To: T10 Technical Committee
From: Rob Elliott, HP (elliott@hp.com)
Date: 3 March 2004
Subject: T10/03-337r3 SPC-3 Third party persistent reservations

Figure 2. Third party persistent reservation

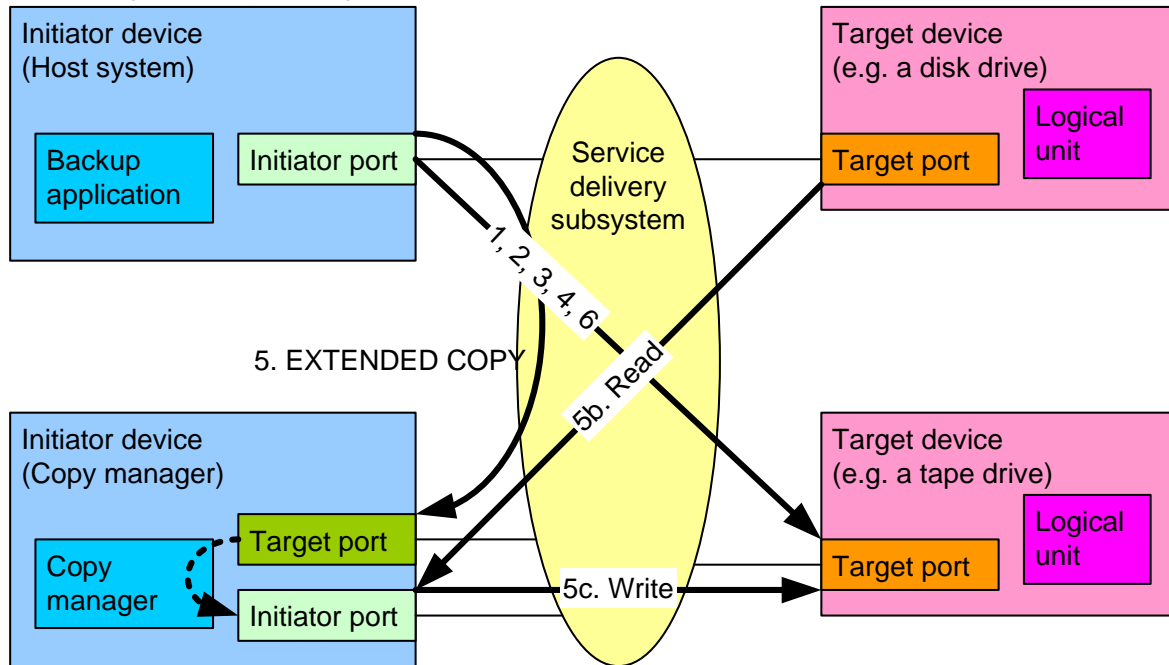
Add a REGISTER and MOVE service actions to both register a specified I_T nexus and move the existing reservation to it, all in one step. Add Specify Initiator Ports functionality to PREEMPT to take back the reservation from a specific I_T nexus.

After it has become a reservation holder through an I_T, the backup application uses a PERSISTENT RESERVE OUT command REGISTER AND MOVE service action with:

- SPEC_I_PT bit set to 1
- parameter data specifying the copy manager's initiator port (exactly one TransportID)
- SERVICE ACTION RESERVATION KEY set to a reservation key for the copy manager
- RESERVATION KEY set to its own reservation key (normal rules for these service actions)

to move its current persistent reservation to the specified initiator port.

It is an error to use this service action if the initiator is not a reservation holder or if more than one initiator port is specified in the parameter list.

The copy manager becomes registered with the specified reservation key and becomes a reservation holder in place of (or in addition to, depending on the reservation type) the backup application. The application should use the same reservation key as the backup application, so if the reservation key is preempted, both the copy manager and the backup application are preempted together.

When it wants to revoke the handover, the backup application uses a PERSISTENT RESERVE OUT command PREEMPT service action or PREEMPT AND ABORT service action with:

- SPEC_I_PT bit set to 1
- parameter data specifying the copy manager's initiator port
- SERVICE ACTION RESERVATION KEY set to the copy manager's reservation key
- RESERVATION KEY set to its own key (normal rules for these service actions)

to unregister the copy manager and make the backup application the reservation holder.
